Replace Air Conditioning and Environmental Controls Mechanical Improvements Phase 3

Project 573-10-600

Subject: M. Randall VA – Mechanical Improvements Ph. 3
VA-573-10-600 MES# 2012 578
Addendum #1

This Addendum No. 1 issued to clarify, add to, revise, and/or delete certain items of the contract documents for this work, constitutes a part of the contract documents.

NEW WORK PLAN - FIRST FLOOR

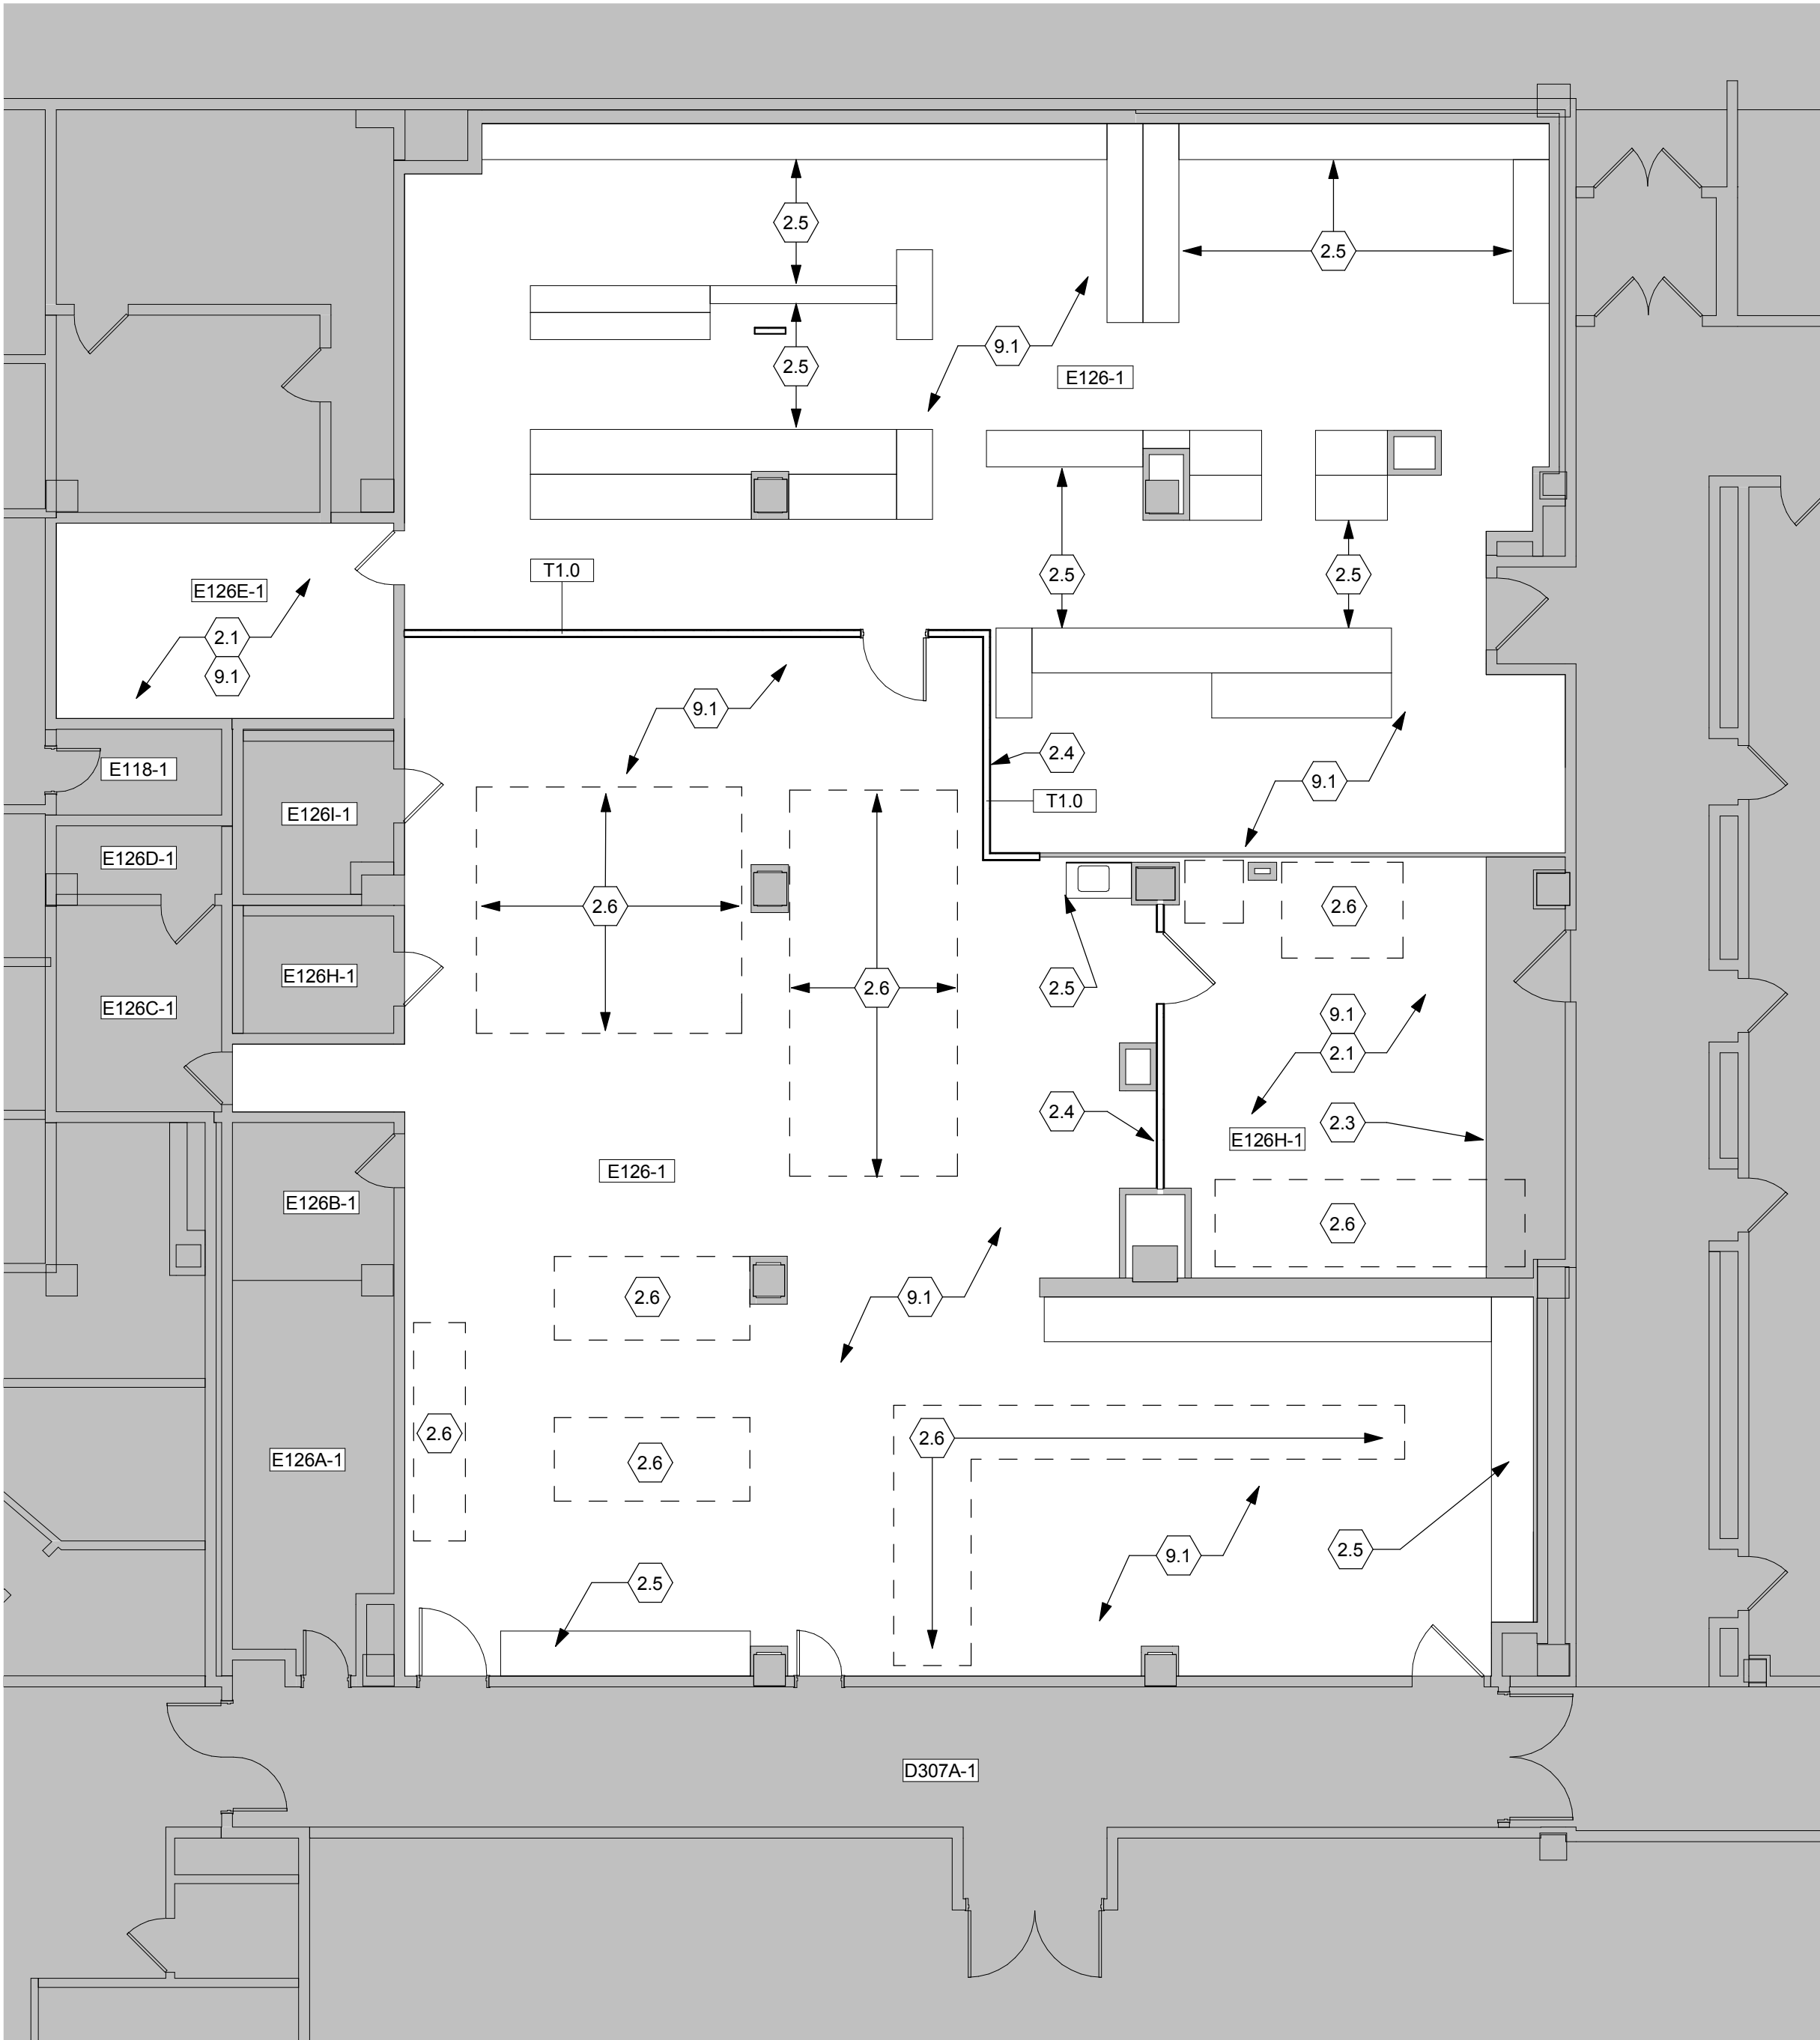
1. Drawing A-102: Added note clarifying Lab construction and demolition Base Bid unless Deduct Alternate #3 is accepted.
2. Drawing A-122: Added note clarifying Lab construction and demolition Base Bid unless Deduct Alternate #3 is accepted.
3. Drawing AD-102: Added note clarifying Lab construction and demolition Base Bid unless Deduct Alternate #3 is accepted.
4. Drawing G-202: Added note clarifying Lab construction and demolition Base Bid unless Deduct Alternate #3 is accepted.
5. Drawing MH-123: Revised ductwork at the Heat Recovery Heat Pipes from parallel flow to counter flow.
6. Drawing MH-506: Revised Plan #7 Existing AC-3E – Refurbished.
Revised notes to read as follow:

Work on this drawing is deduct if Deduct Alternate #3 is accepted.
